UNITED STATES
DEPARTMENT OF THE INTERIOR
BUREAU OF LAND MANAGEMENTREC'D NMOCD
10/22/2020FORM APPROVED
OMB NO. 1004-0137
Expires: January 31, 2018**SUNDRY NOTICES AND REPORTS ON WELLS**
Do not use this form for proposals to drill or to re-enter an abandoned well. Use form 3160-3 (APD) for such proposals.5. Lease Serial No.
NMNM05039A

POKER LAKE UNIT 21 BD 126H

XTO Permian Operating, LLC, requests permission to make the following changes to the original APD:

**** BLM REVISED ** BLM REVISED ** BLM REVISED ** BLM REVISED ** BLM REVISED ******KP 10/30/2020 GEO Review**

Annular packoff with both external and internal seals

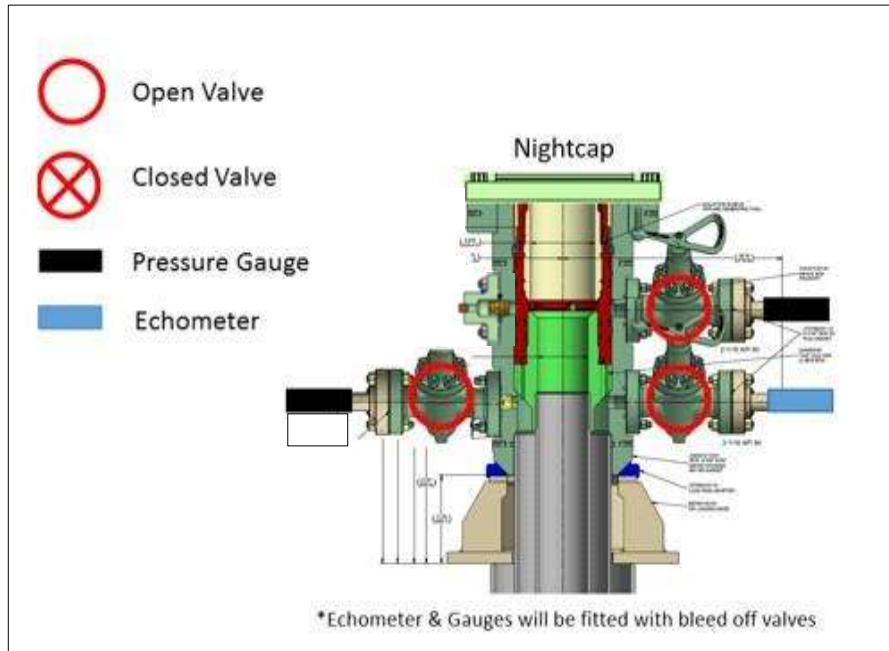
1. Run casing as per normal operations. While running casing, conduct negative pressure test and confirm integrity of the float equipment (float collar and shoe)
2. Land casing with mandrel
3. Fill pipe with kill weight fluid, do not circulate through floats and confirm well is static
4. Set annular packoff shown below and pressure test to confirm integrity of the seal. Pressure ratings of wellhead components and valves is 5,000 psi.
5. After confirmation of both annular barriers and internal barriers, nipple down BOP and install cap flange.
 - a. If any barrier fails to test, the BOP stack will not be nipped down until after the cement job is completed with cement 500ft above the highest formation capable of flow with kill weight mud above or after it has achieved 50-psi compressive strength if kill weight fluid cannot be verified.

Wellhead diagram during offline cementing operations

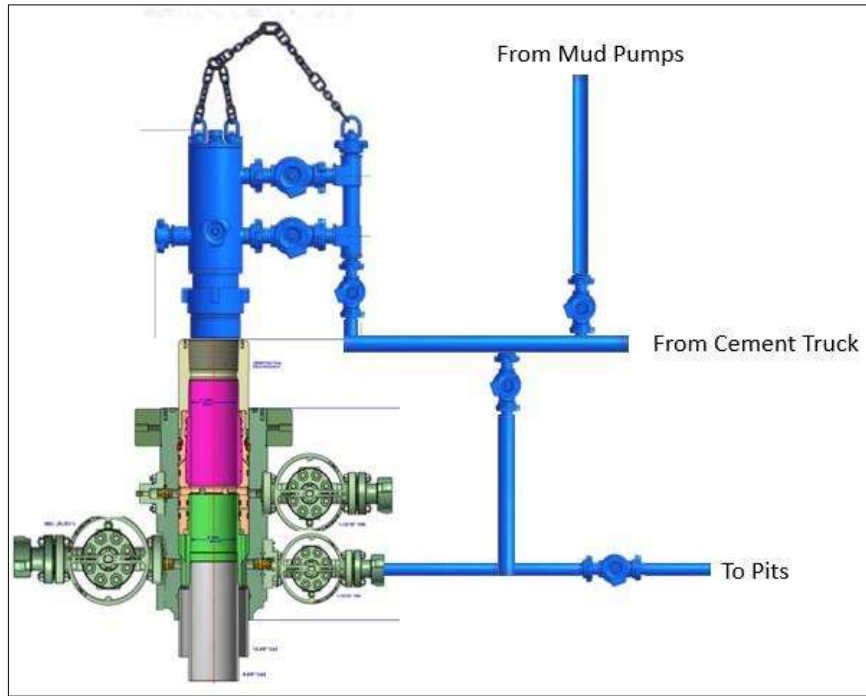
10. Circulate bottoms up with cement truck
 - a. If gas is present on bottoms up, well will be shut in and returns rerouted through gas buster to handle entrained gas
 - b. Max anticipated time before circulating with cement truck is 6 hrs
11. Perform cement job taking returns from the annulus wellhead valve
12. Confirm well is static and floats are holding after cement job
13. Remove cement equipment, offline cement tools and install night cap with pressure gauge for monitoring.
